CML1929 - Response to Consultee Comments Marine Licence Application for the Greenlink Interconnector

P1975_R5015_Rev1

CML1929 - Response to Consultee Comments

Marine Licence Application for the Greenlink Interconnector

Drawing No: P1975-SED-007

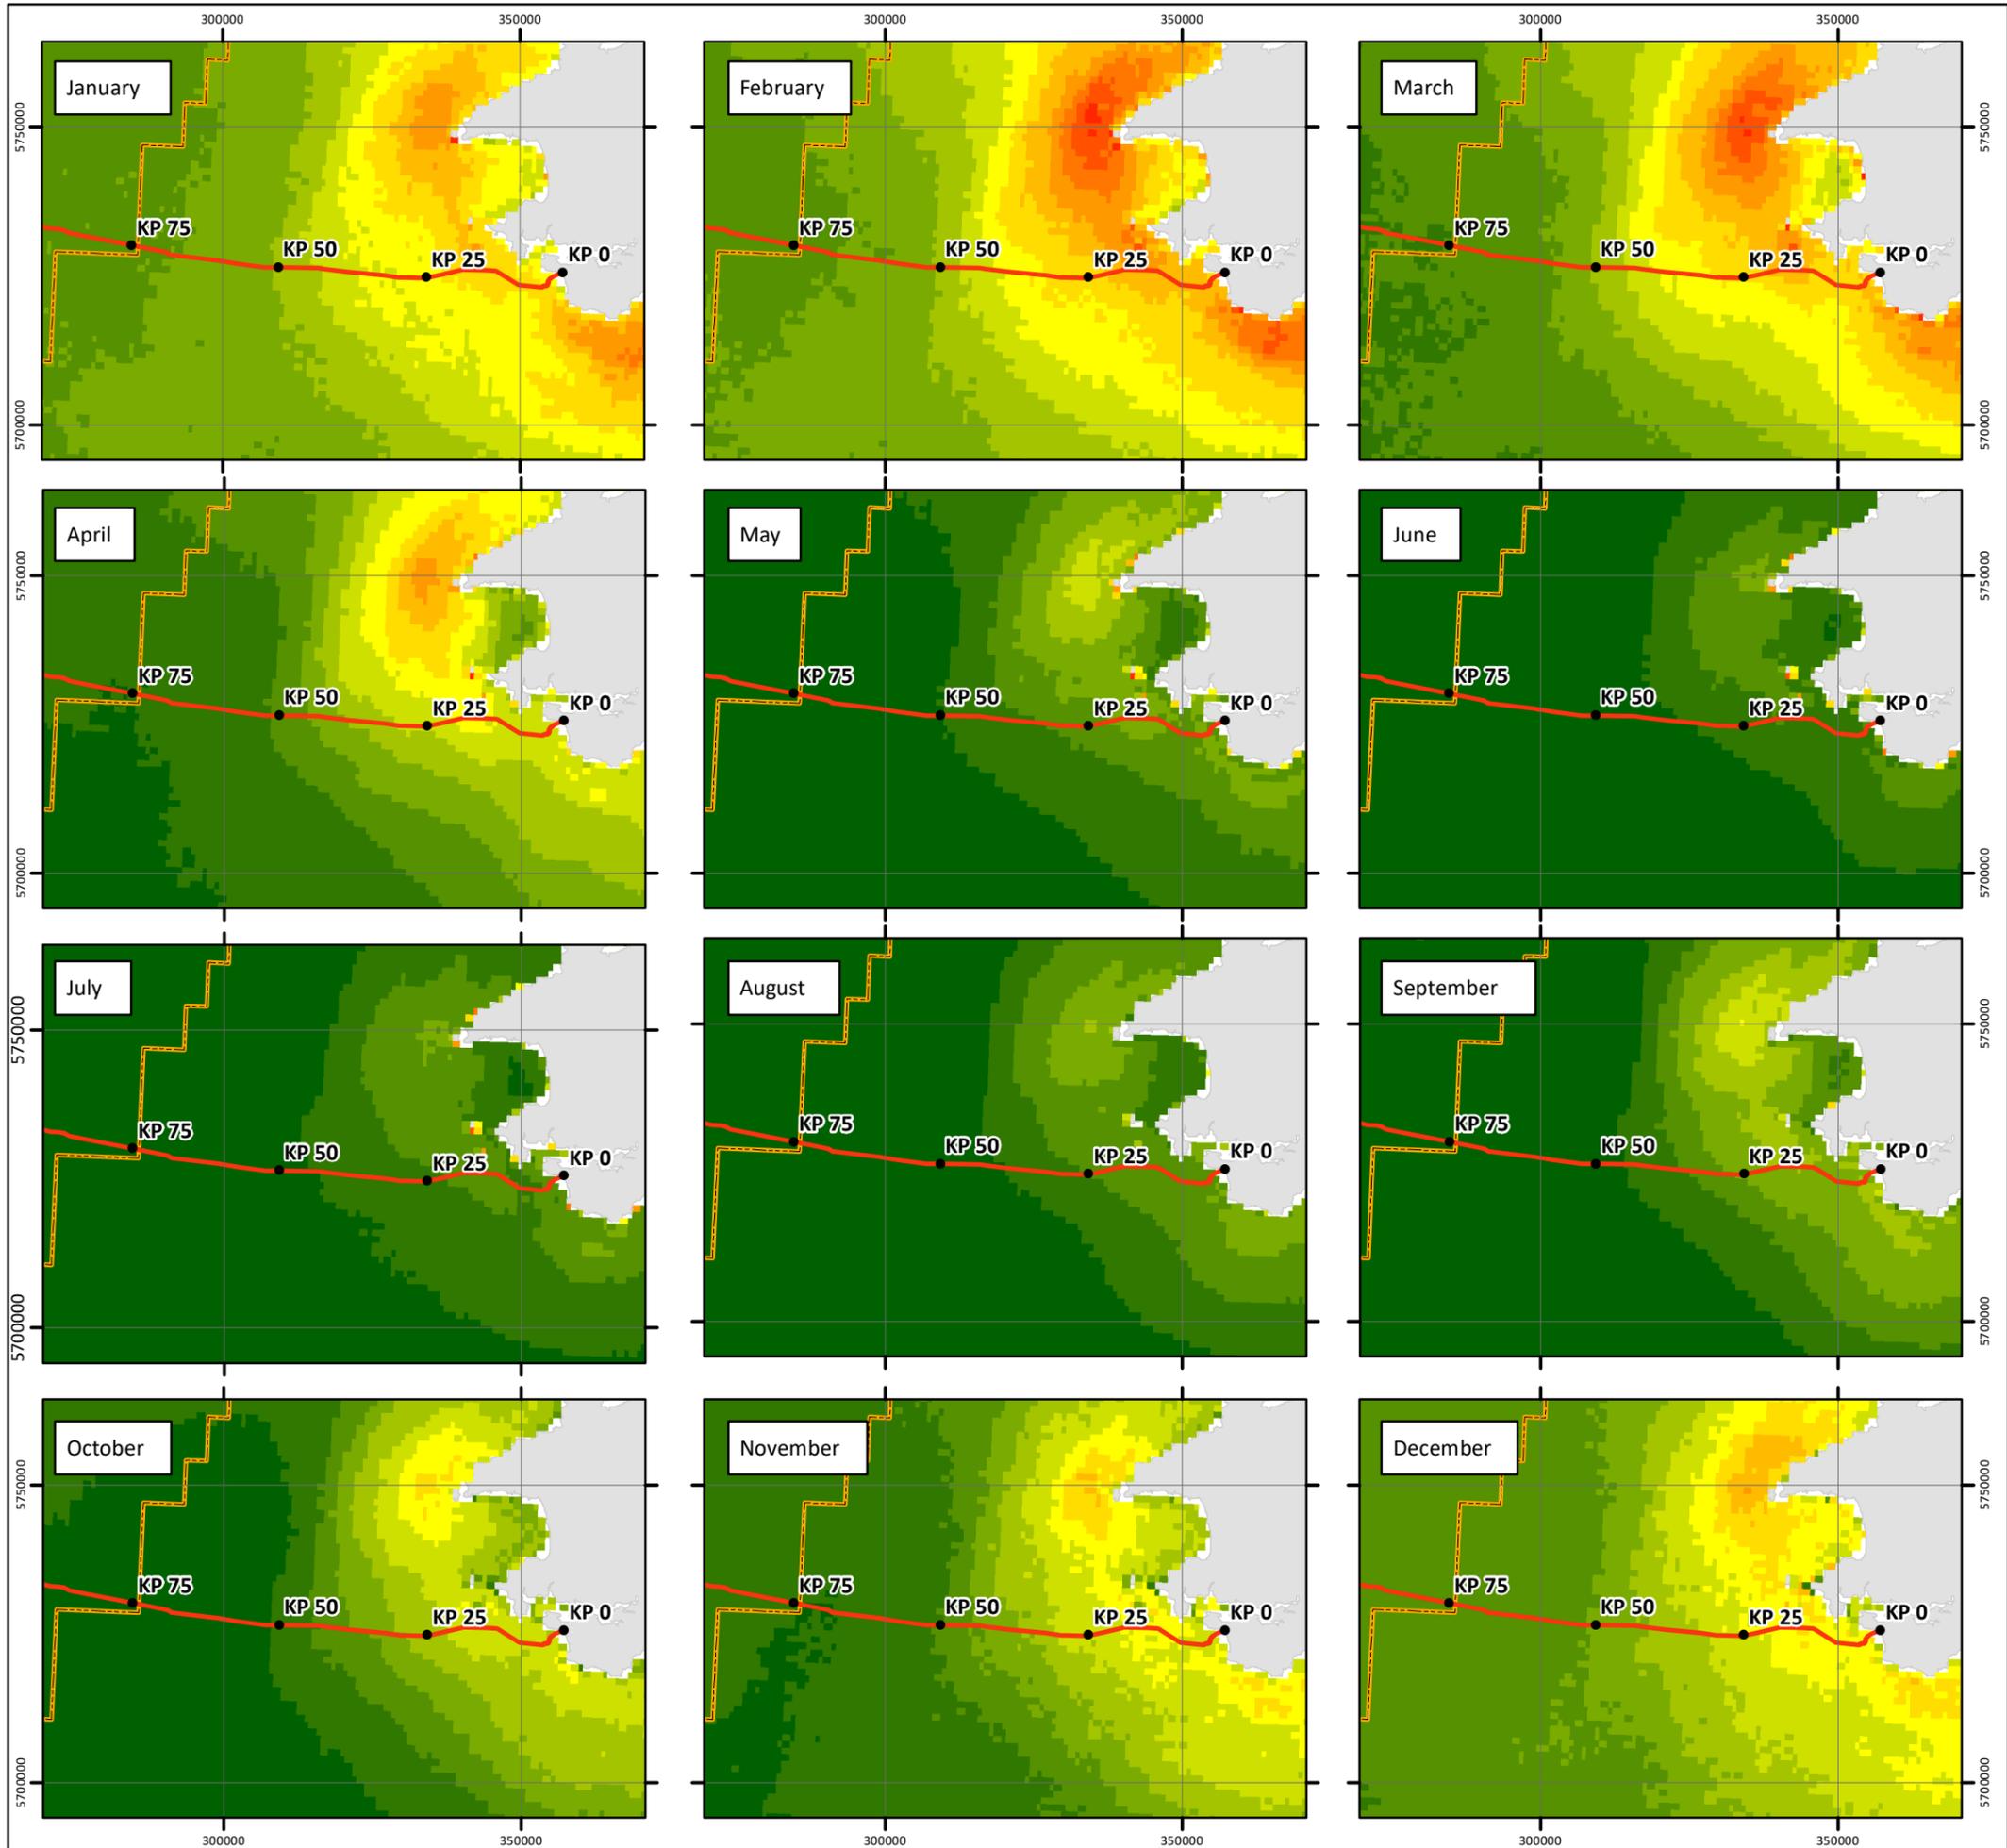
Referring to section 6.3.5.2. (pg 6-26) there is some confusion around the average Suspended Particle Matter (SPM) off the Pembrokeshire coast. First, the average is stated to be 5-10 mg/l for 1998 to 2015 and later the autumn/winter concentrations

are 5 mg/l; storm values are said to be in excess of 10 mg/l. These values suggest 10 mg/l cannot be an average. In section 6.6.3., these values are discussed further, but in terms of the “Proposed development”. As the proposed development spans from Pembrokeshire to Ireland (or in the UKs case to the median line) it would be useful to understand the spatial and temporal variability more clearly. Having checked the reference provided, we note that the information provided is from satellite imagery and appears to be spatially averaged to “Western English Channel & Celtic Seas”. The average from this huge area does not provide enough information nearshore or offshore to understand background concentrations and potential impacts; further background information should be sought. The applicant should be made aware that NRW hold SPM data within WFD waterbodies which they can access from data distribution.

Intertek approached NRW data distribution for additional information to address this comment. Whilst the information provided did contain SPM data within WFB waterbodies there were no measurements for the coastal waterbodies. Measurements focused on riverine environments.

Intertek therefore revisited the Cefas (2016) data source and were able to obtain GIS layers showing the breakdown of SPM concentrations but at a higher resolution. Drawing P1975-SED-007 illustrates the seasonal variation in SPM concentrations along the Proposed Development (which refers to the Greenlink project from MHWS to the UK median line). Background SPM concentrations are higher over winter months, and can exceed 10mg/l during January, February and March in inshore waters i.e. between KP0 and approximately KP20. From May to September as wave conditions calm, SPM concentrations fall to 5mg/l or less. Further offshore around the UK median line SPM concentrations are consistently lower than inshore, but still show seasonal fluctuations.
